CITY OF COCONUT CREEK

DEVELOPMENT REVIEW COMMITTEE (DRC) REVIEW #1

04-10-18

PROJECT NAME:		Lyons Community Center Site	
PROJECT NUMBER:		18030005	
LOCATION:			
APPLICANT/AGENT:		Debra Hernandez, RLA, IBI Group	
REVIEW/APPLICATION		Site	
DISCIPLINE	REVIEWER	EMAIL	TELEPHONE
DRC Chair	Liz Aguiar – Principal Planner	laguiar@coconutcreek.net	(954) 973-6756
Planning	Linda Whitman – Senior Planner	lwhitman@coconutcreek.net	(954) 973-6756
Planning	Natacha Josiah – Planner	NJosiah@coconutcreek.net	(954) 973-6756
Building	Sean Flanagan - Chief Structural Inspector	sflanagan@coconutcreek.net	(954) 973-6750
Engineering	Eileen Cabrera - Engineer II	ecabrera@coconutcreek.net	(954) 973-6786
Fire	Jeff Gary – Fire Marshal	jgary@coconutcreek.net	(954) 973-1563
Landscape	Scott Peavler - Landscape (consultant)	speavler@craventhompson.com	(954) 739-6400
Police	Brandi Delvecchio - Police Department	bdelvecchio@coconutcreek.net	(954) 956-6721

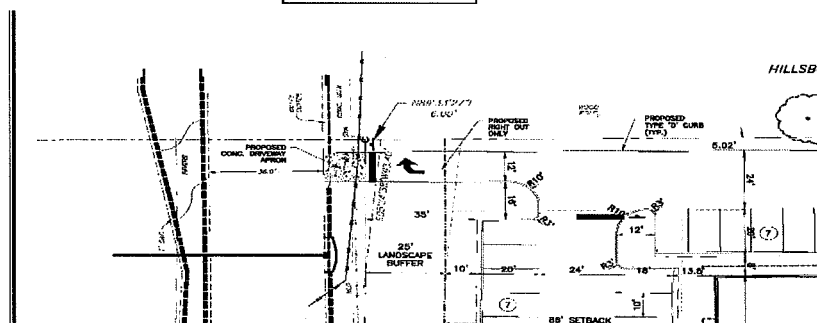
7. Provide 25 LF double yellow pavement markings for all stop signs/ stop bar locations.

Response: As shown on Sheet 6.0, the south entry/exit driveway connection provides a note to install 25 lf double yellow, stop sign and stop bar. The northwest driveway connection is an exit-only drive and provides for a stop sign, stop bar, right-turn only and do not enter sign.
